City of Brisbane

Planning Commission Agenda Report

SUBJECT: **3000-3500 Marina Boulevard; Design Permit Modification DP-1-21 (modification to DP-1-18); SP-CRO Sierra Point Commercial District;** Design Permit revision to modify the exterior materials on all building elevations of the three-building biotech campus previously approved under DP-1-18 (2018); David Diamond, applicant; Bp3 Sf5 3000 3500 Marina LLC, owner.

Building Design, Planning Submission Comparison

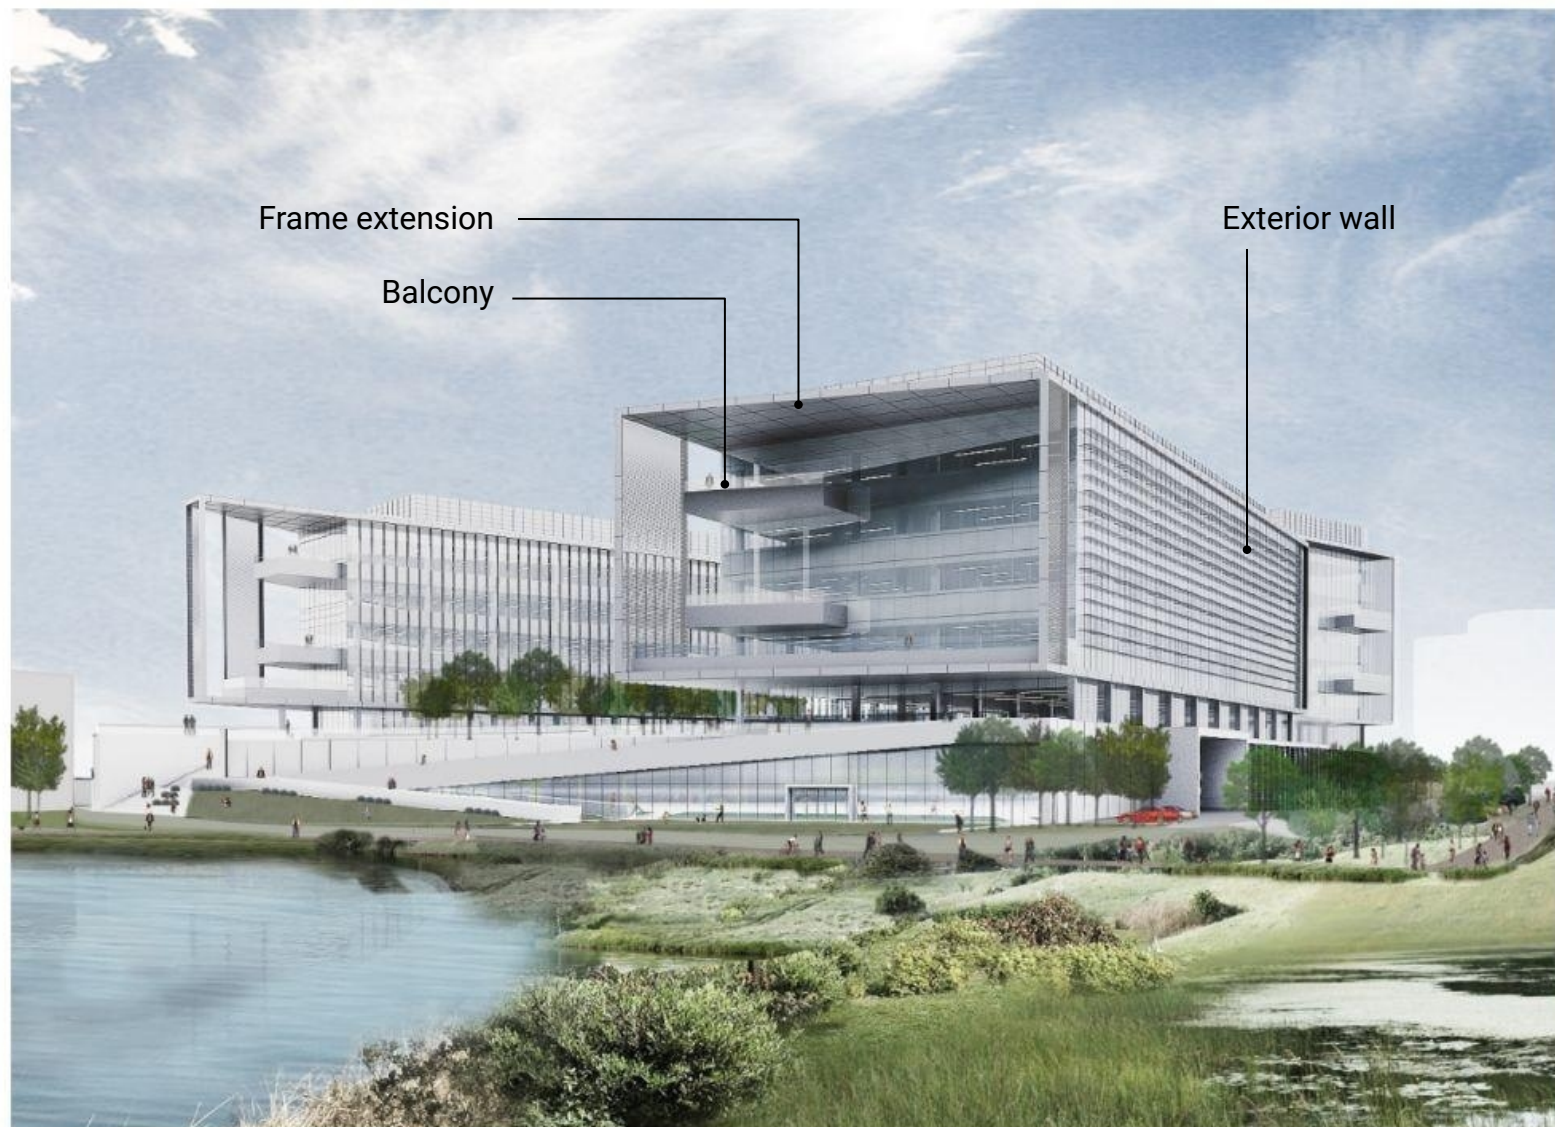
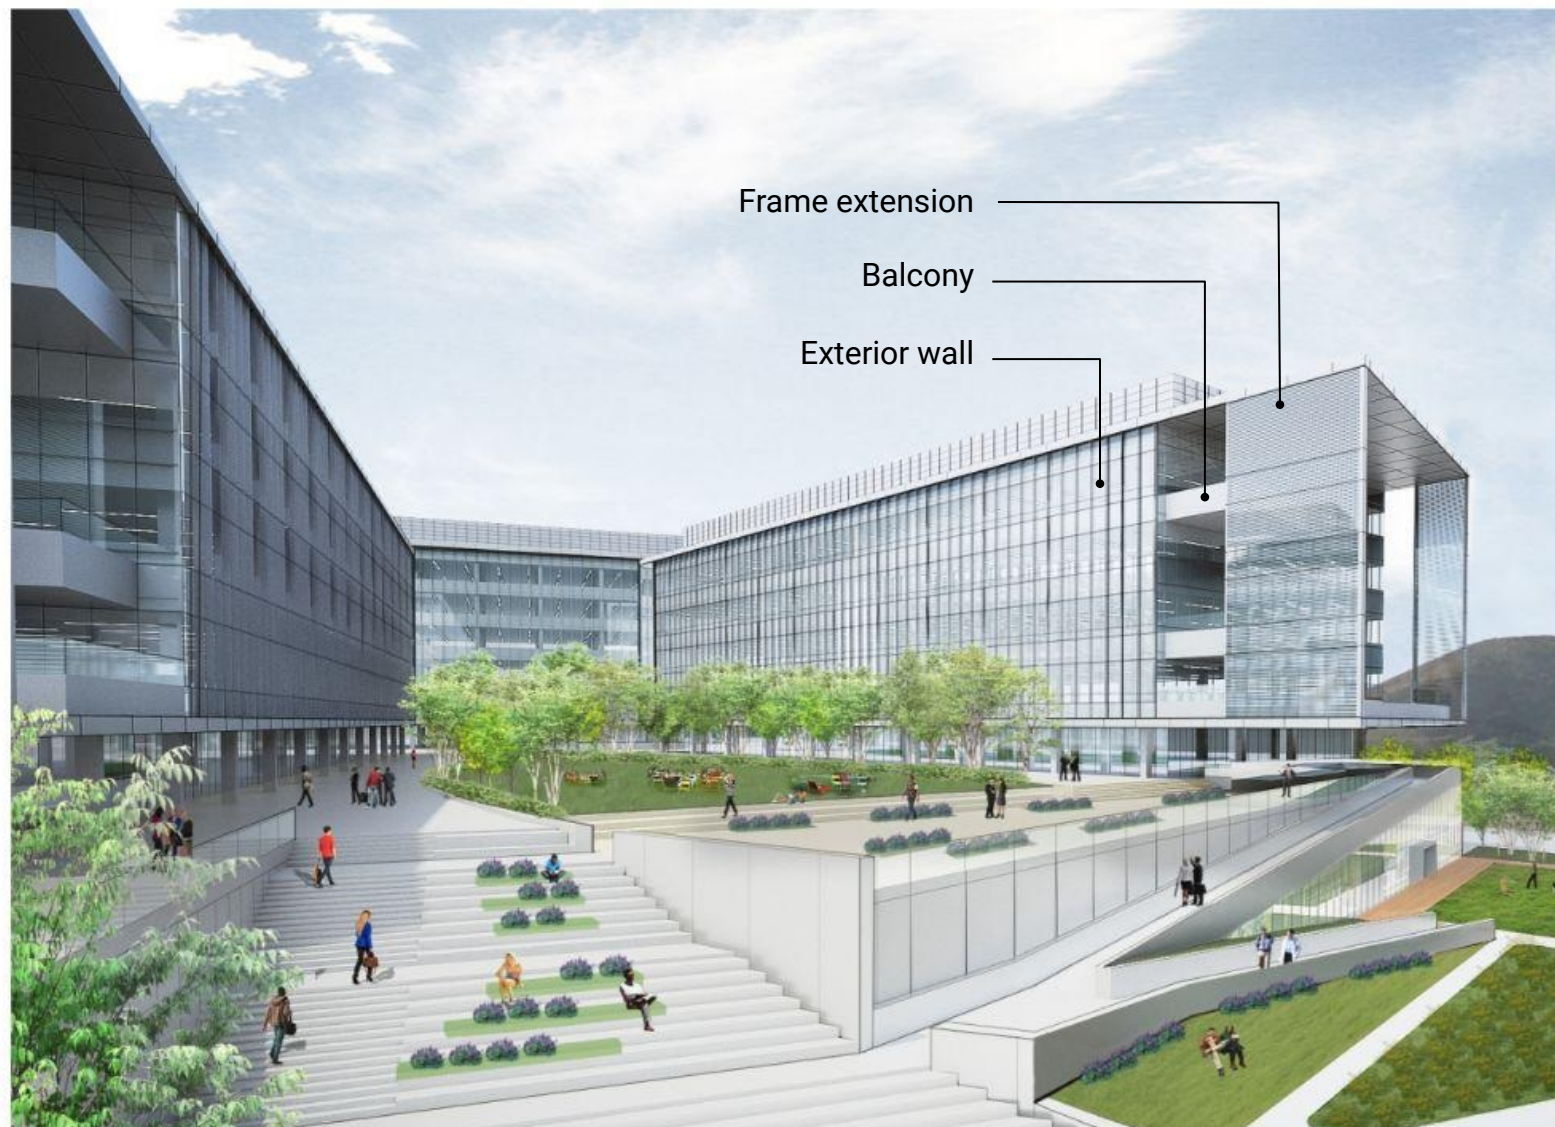
- Modify the dimensions and floor level locations of the cantilevered balconies on the north elevations of Building's 1 and 2 and west elevation of Building 3;
- Eliminate the balconies on the south elevations of Buildings 1 and 2 and east elevation of Building 3; and
- Reduce the dimensions and modify materials of the overhanging roof and side wall projections at the north and south elevations of Buildings 1 and 2 and west and east elevations of Building 3.
- Modify the interior and exterior wall elevations (relative to the interior courtyard) from a flat glass wall with projecting vertical glass fins (interior wall planes) or projecting horizontal metal fins (exterior wall planes) with a consistent "sawtooth" glass curtain wall at all elevations.

The applicant proposes to modify the north and south elevations of Buildings 1 and 2 and the west and east elevations of Building 3 related to exterior balconies and associated projecting balcony overhangs. The applicant additionally proposes modifications to the interior and exterior wall elevations (relative to the interior courtyard), revising the wall plane geometry, accent materials, and glass finishes and treatment. The modifications to each building are shown in the applicant's plans and renderings in Attachment B.

Building 1 Ends

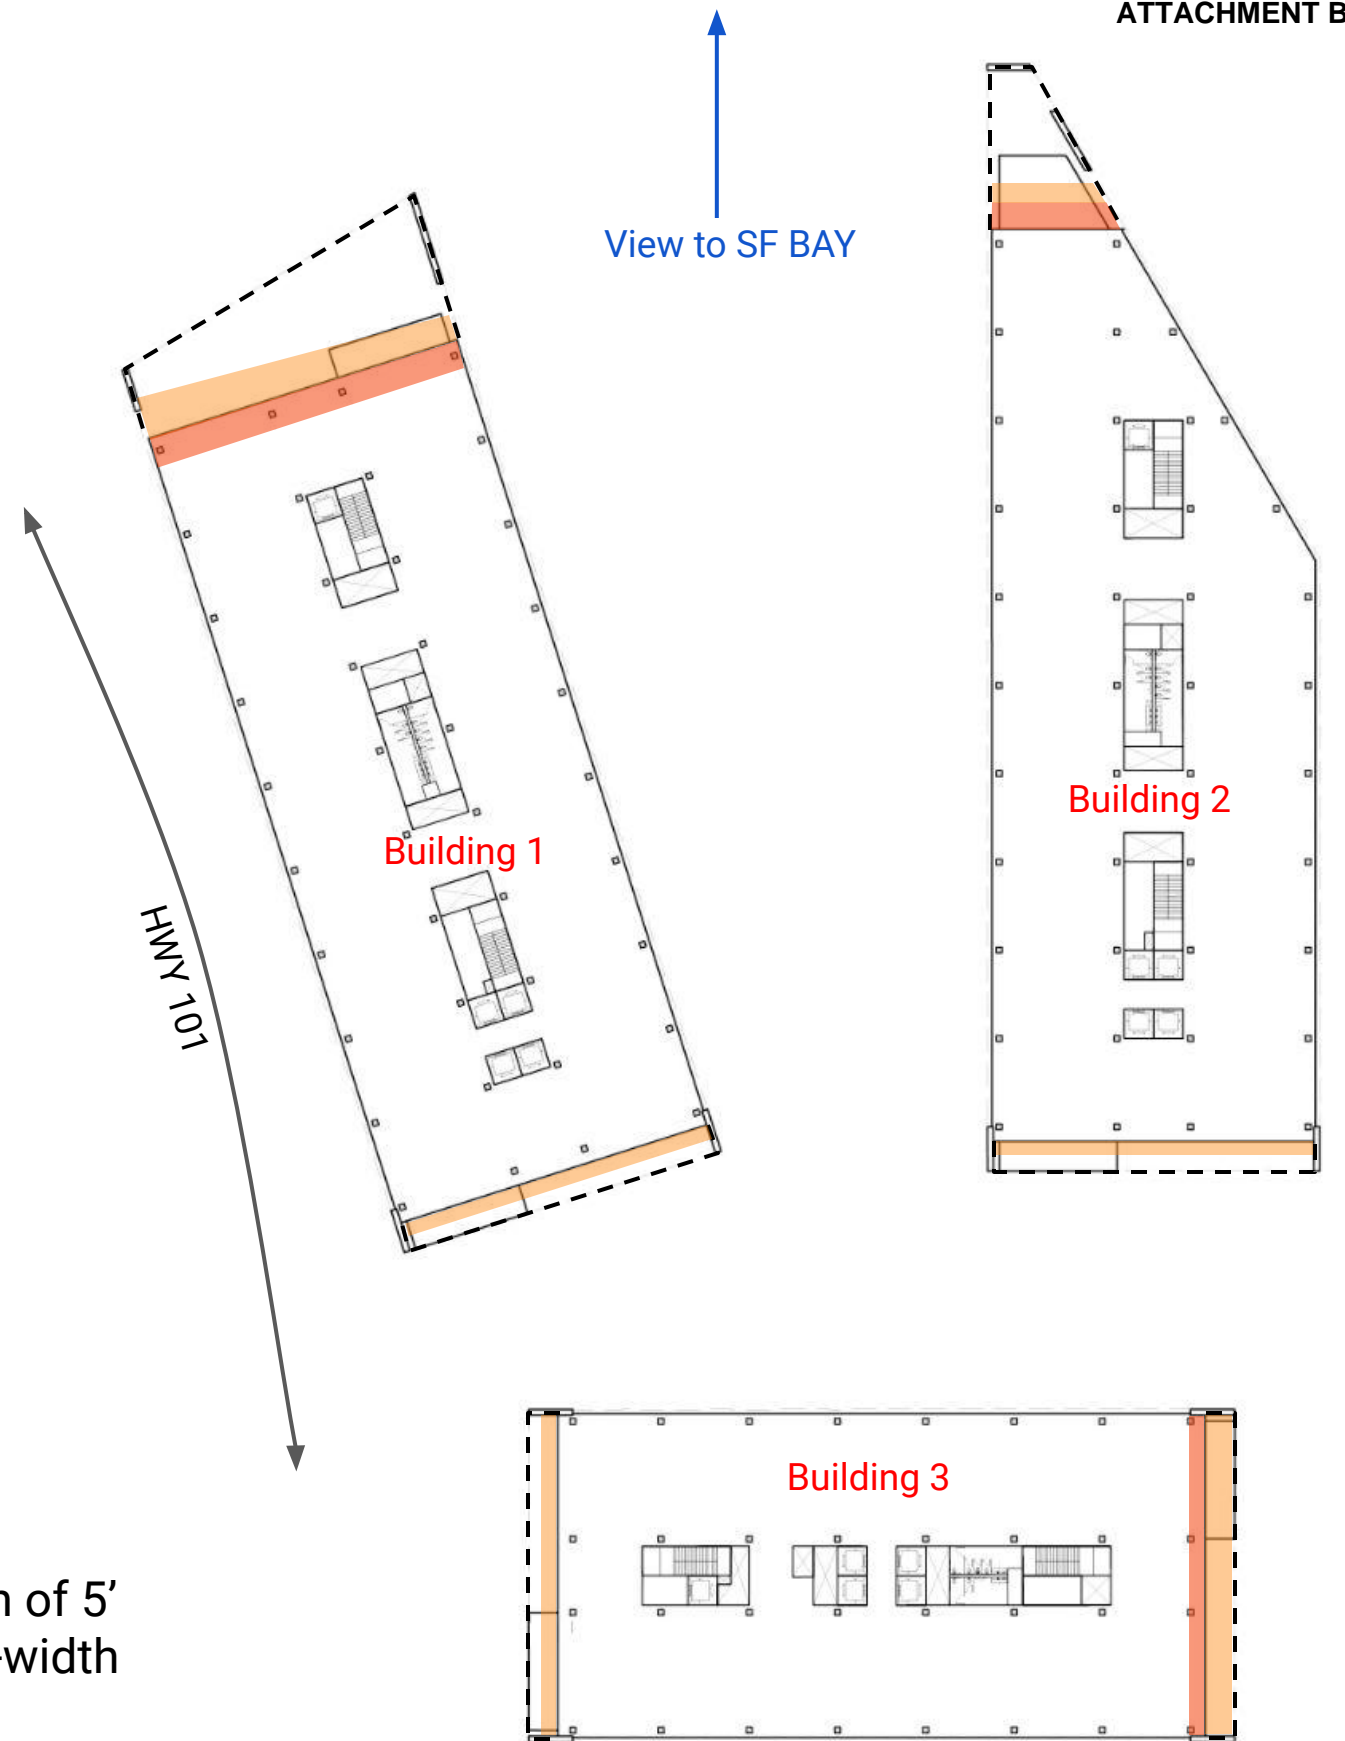
- North frame overhanging roof projection reduced to a dimension varying 5' to 10'
- South frame overhanging roof projection reduced to a dimension of 5'
- North end partial-width projecting balconies at L4 & L6 replaced with full-width inset and covered balconies at L3 & L6
- South end partial-width projecting balconies at L4 & L6 removed

Exterior Wall - Outward Facing Long Building Elevations

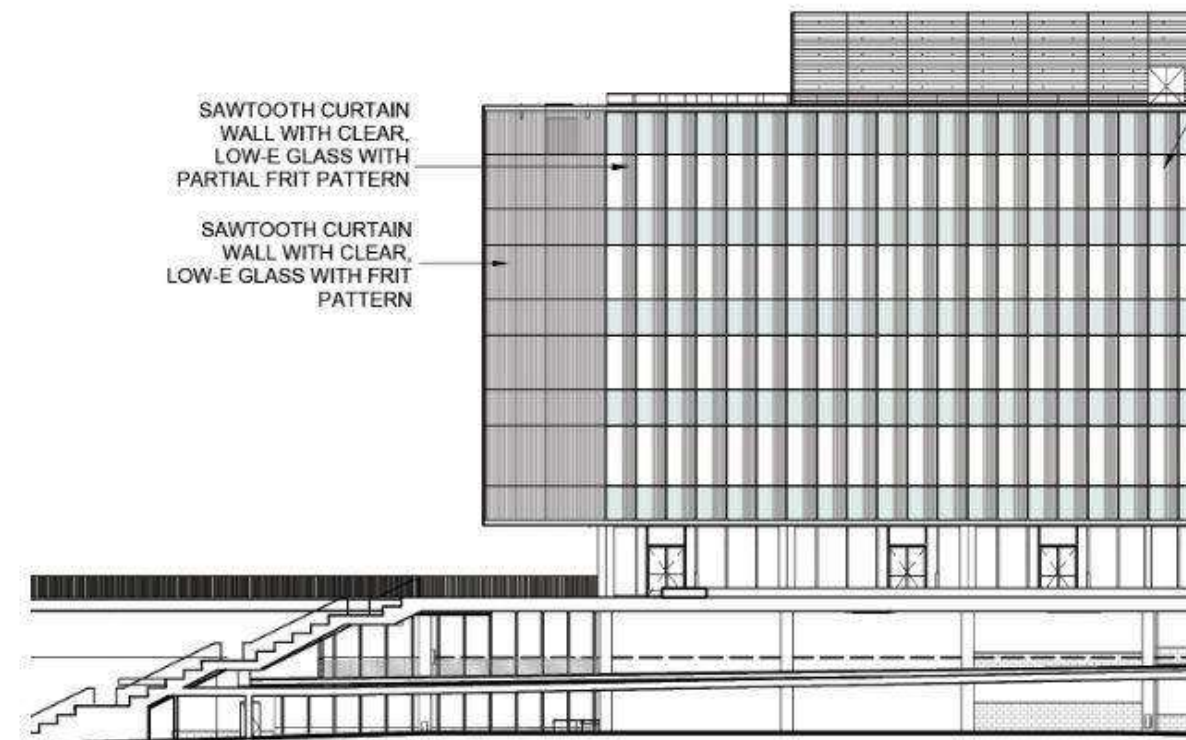
Flat glass curtain wall with projecting horizontal aluminum fins replaced with “sawtooth” curtain wall units with integral vertical fins on one side of each unit.

Proposed Exterior Wall Design- Solar Orientation

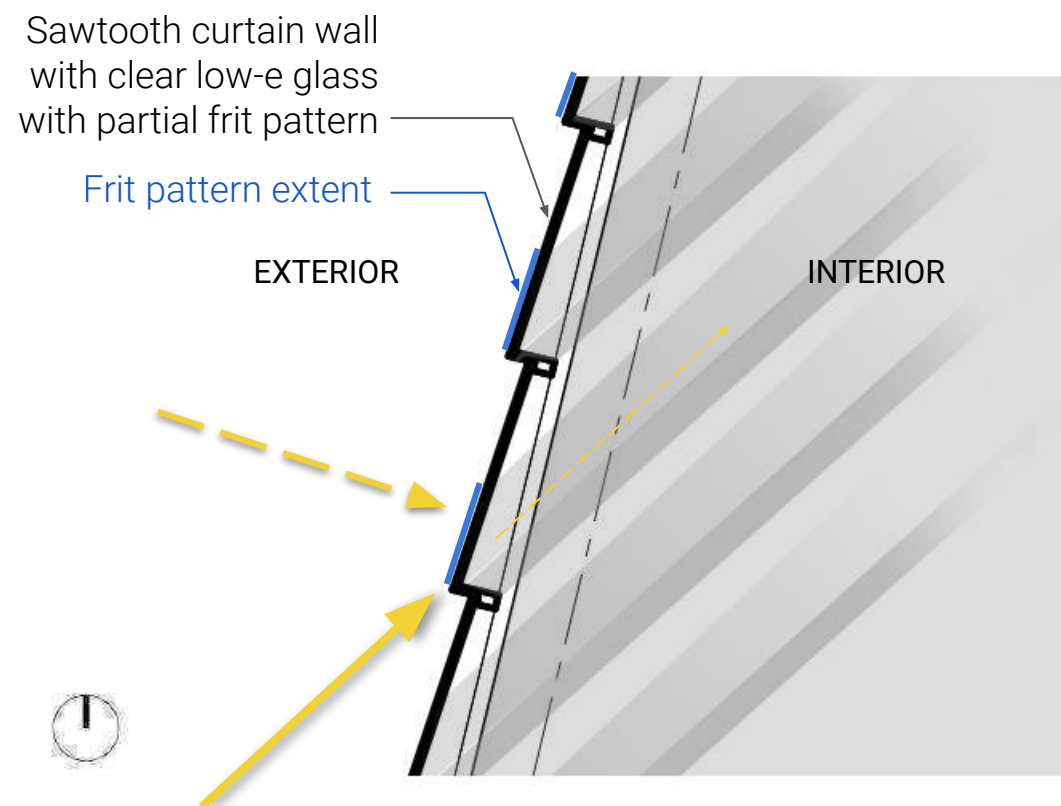
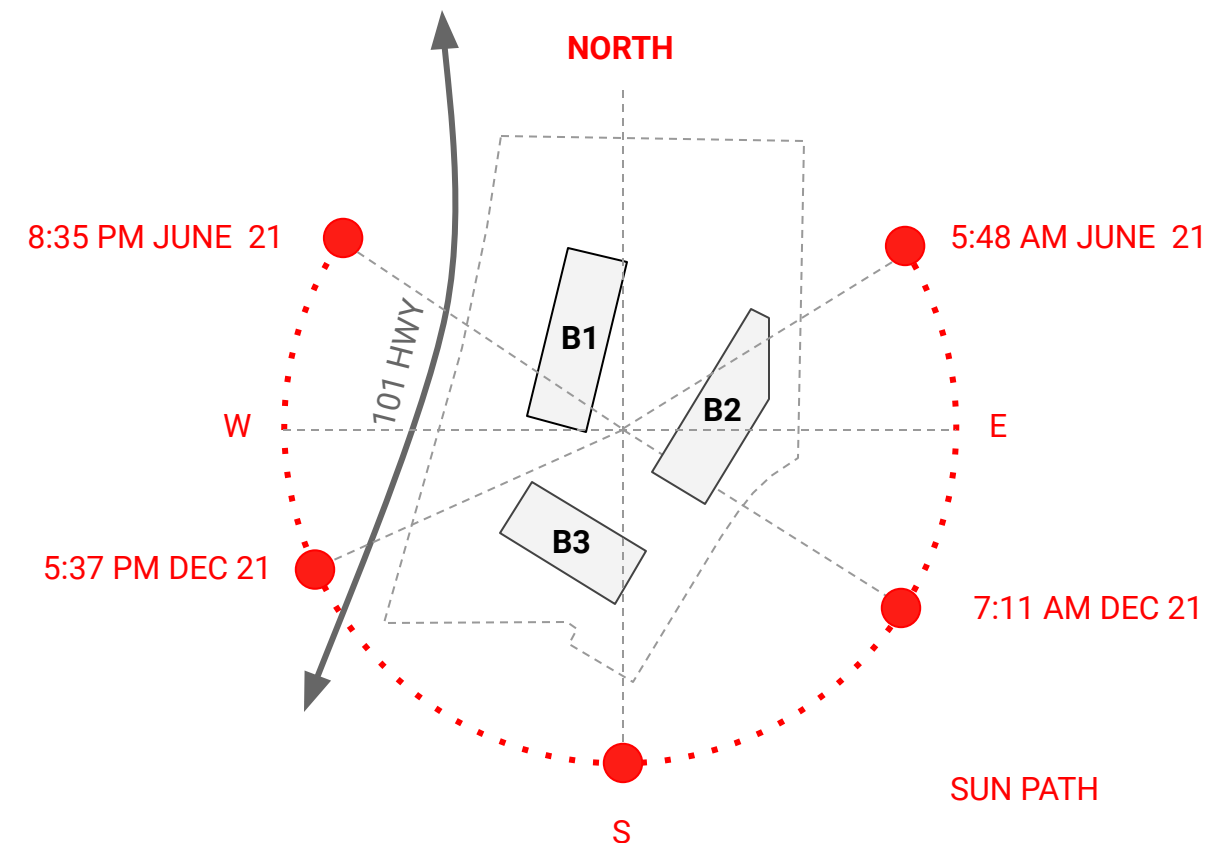
- The vertical projection on the sawtooth geometry helps shading from the south and southwest sun.
- The frit pattern helps shading and overall glare reduction from the low western and eastern sun.
